Kahler Slater is pleased to submit this updated information to the Urban Design Commission as information required for the project's Final Approval for a hotel to be located along Pinckney Street at Judge Doyle Square. Approvals have been secured from both Plan Commission, City Council, and the UDC (save for a few conditions) which were obtained earlier this year. The outstanding conditions to obtain final approval from the UDC included the following:

JUDGE DOYLE SQUARE

HOTEL DEVELOPMENT | BLOCK 105 | MADISON, WISCONSIN

CITY OF MADISON UDC SUBMITTAL
JULY 28, 2021 (REVISED AUG 26)

D. SITE & LANDSCAPE PLAN (LANDSCAPE PLAN UPDATE)

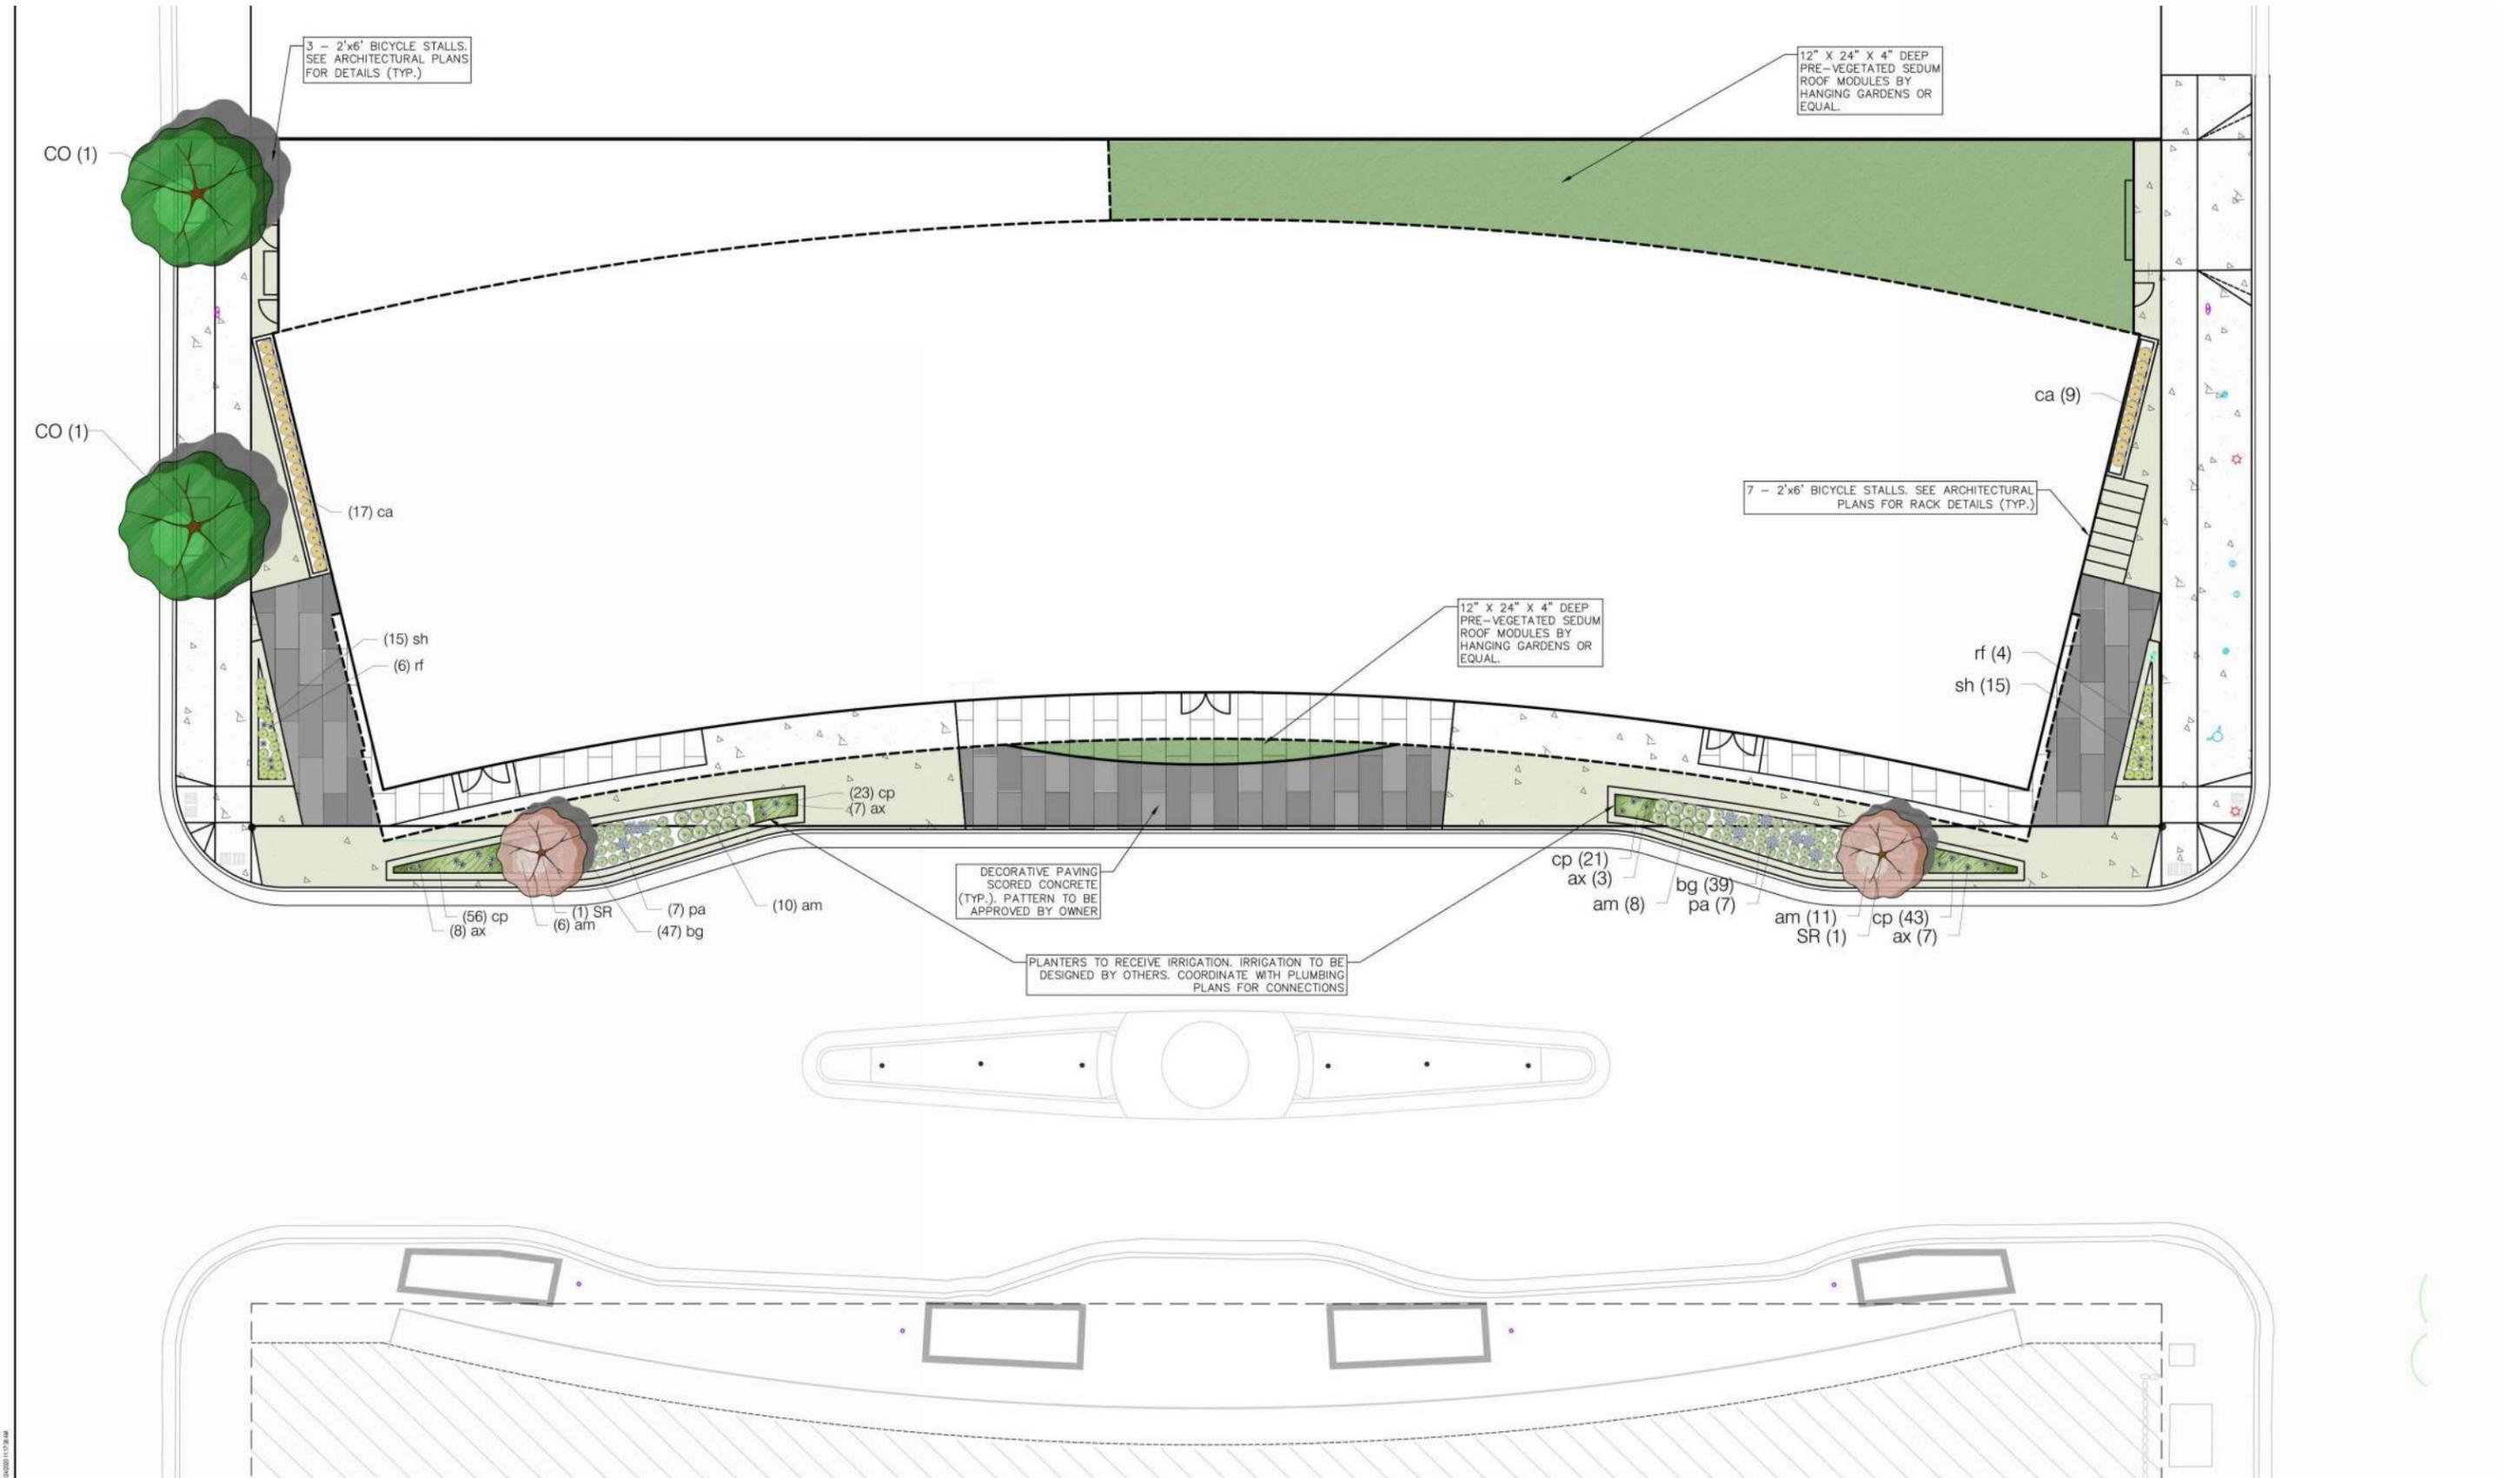
62d. Refinement of the planters/plantings by eliminating the Juniper in favor of something like Prairie Drop Seed, adding more planting materials to fill them, and looking at shifting some bike racks to Doty Street.

The landscaping plan has been refined per the comments with more plants and species replacement. The bike racks have been distributed along both streets and have been coordinated to keep out of the public right of way.
